**2008 EASTON POINT
RESIDENTIAL
DEVELOPMENT**

***Final Environmental Impact
Report***

***Response to Comments to the
Draft Environmental Impact
Report AMENDMENT***

MARIN COUNTY

Exhibit 3.0-4
Proposed Master Plan

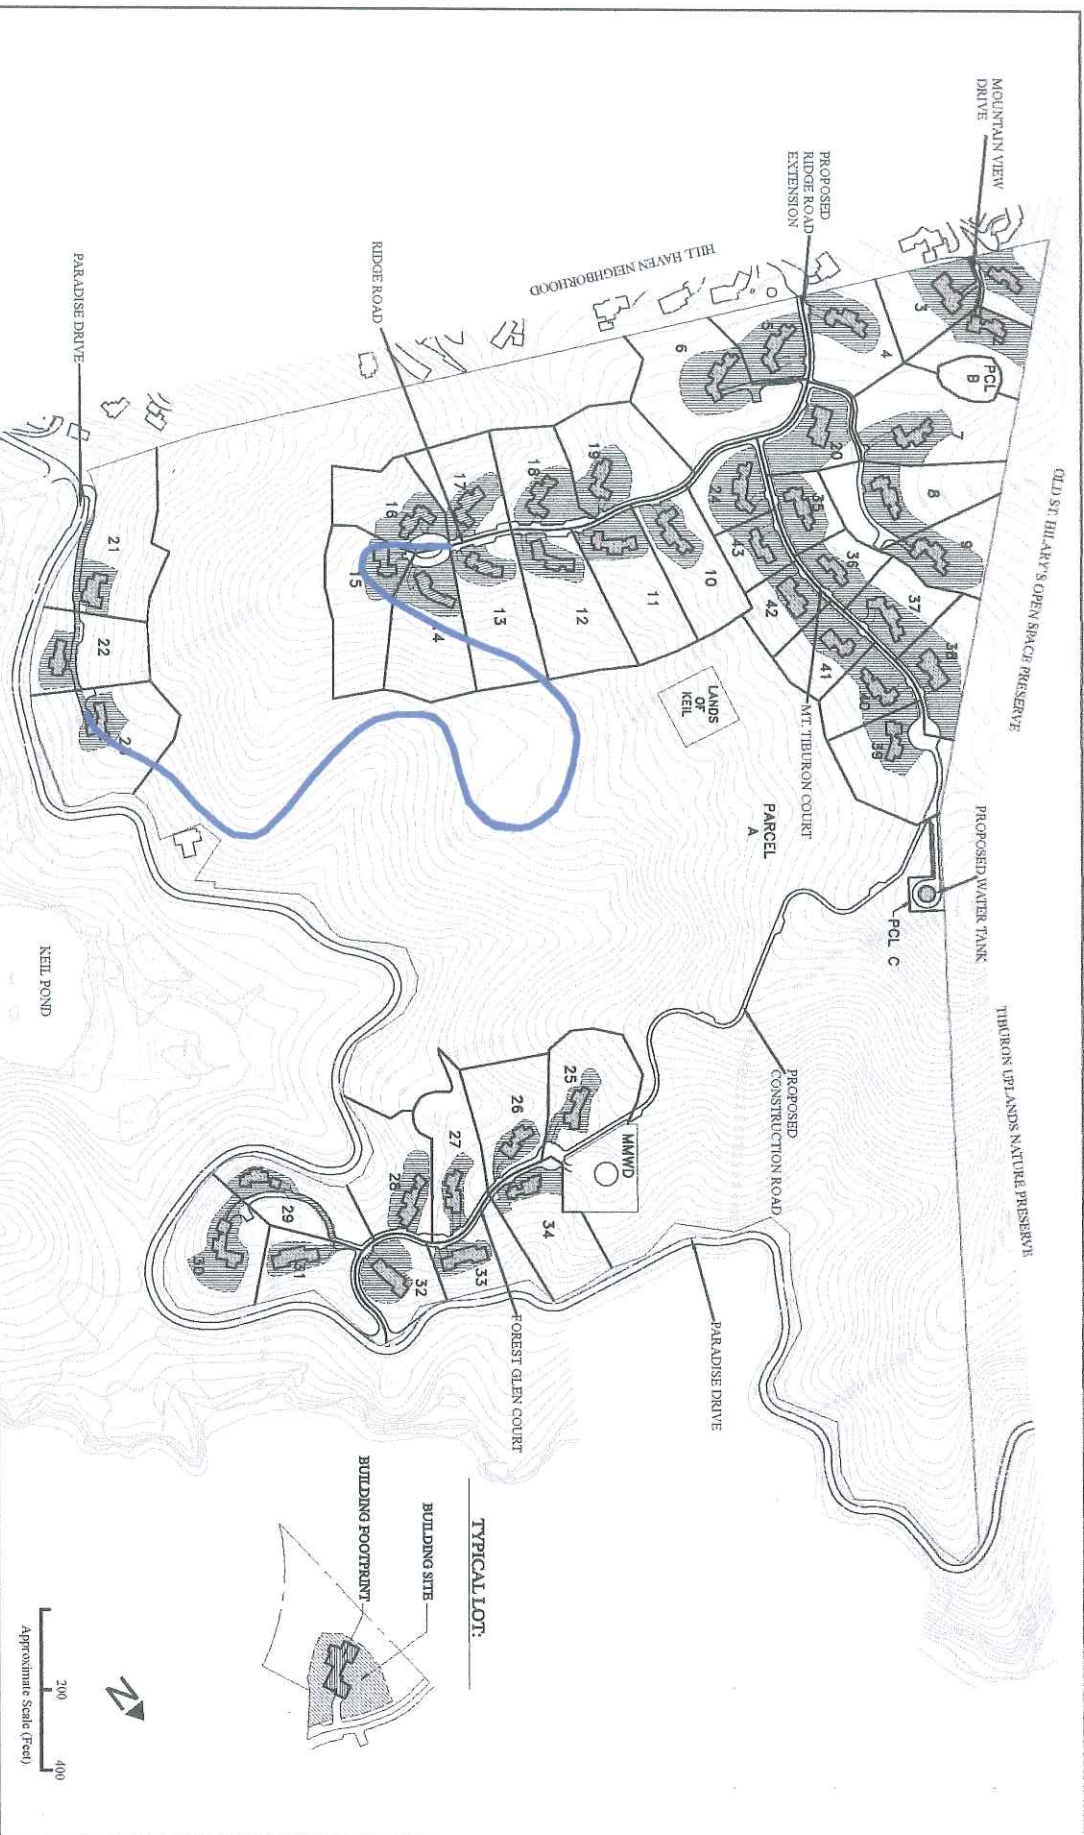
There are 28 known landslide areas on the property. (See Exhibit 3.0-9 of the DEIR.) The applicant asserts that its development plan is in conformance with the U.S. District Court's Judgment Pursuant to Stipulation, filed November 8, 2007, which requires that lots be placed on "geologically safe portions of the site, without the necessity for extensive landslide repair, rather than in the path of known landslides." Contrary to the applicant's assertions, the project site is mapped as being underlain by 28 known landslides, and the development plan shows many lots on and in the path of these known landslides. (Compare Exhibits 3.0-4 and 6.0-2 of the DEIR to Exhibit 3.0-9.) These lots clearly are not outside "the path of known landslides" and are therefore in direct violation of the 2007 Judgment.

Landslide Vectors on Martha Property

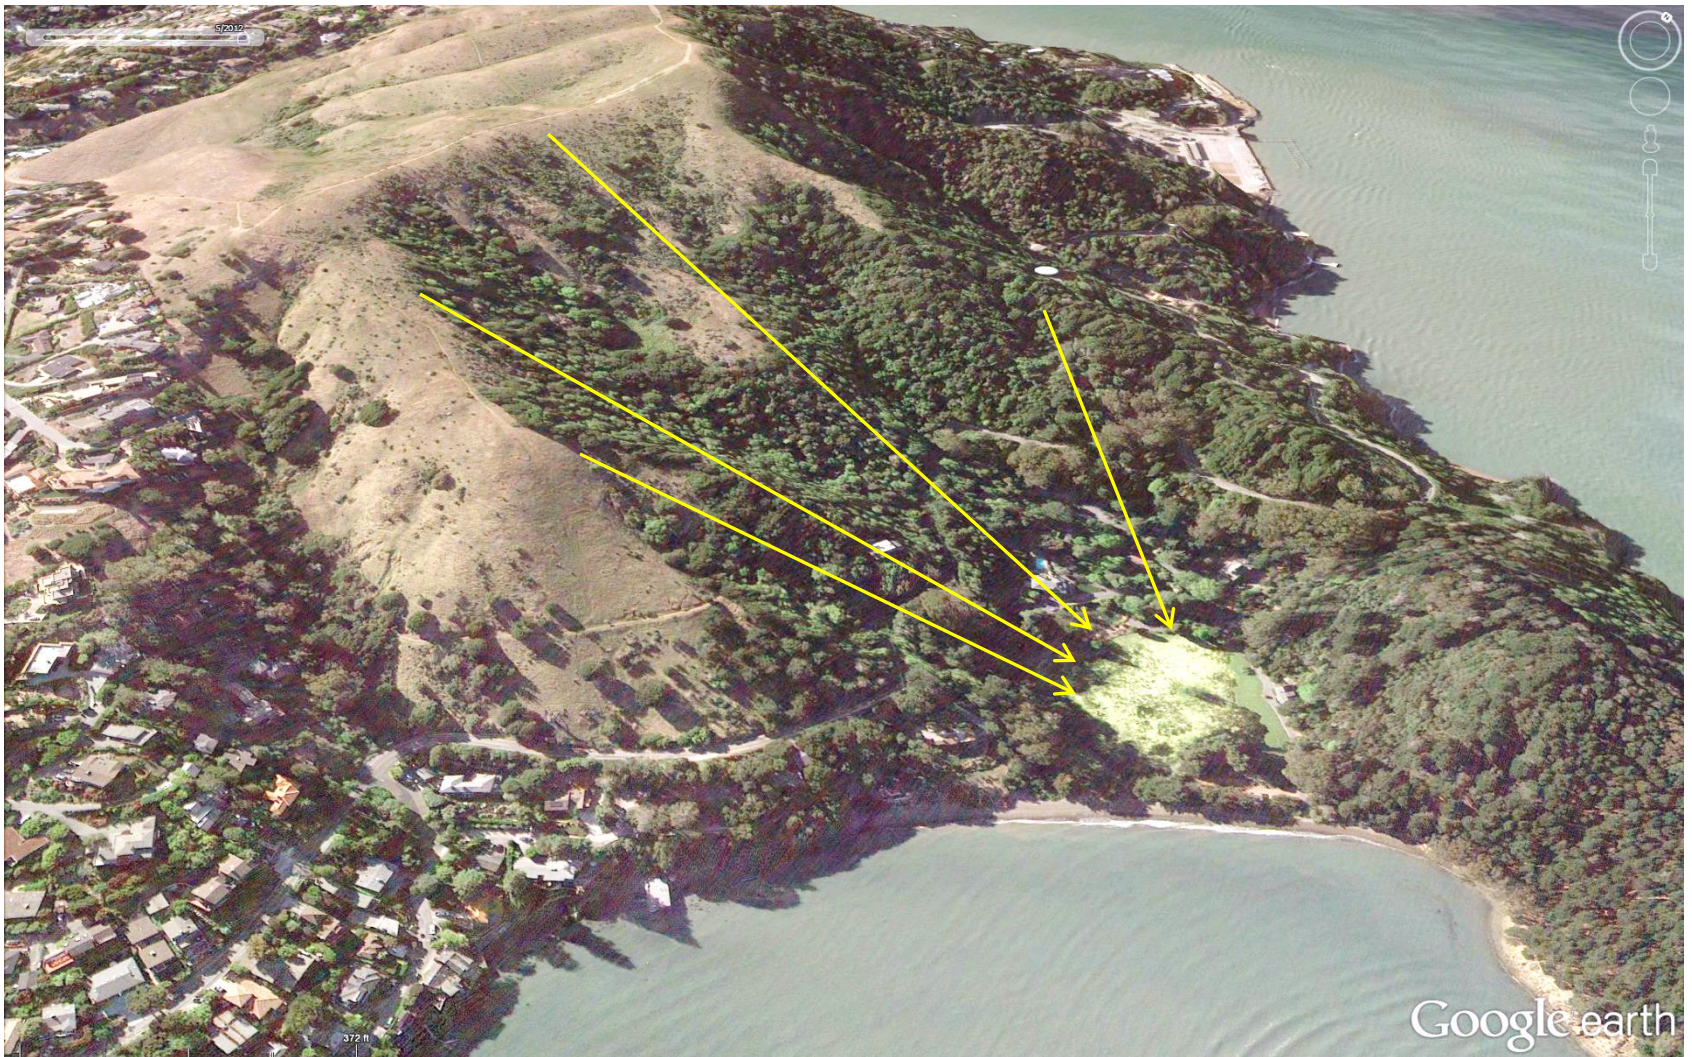
Proposed Lot Site Locations
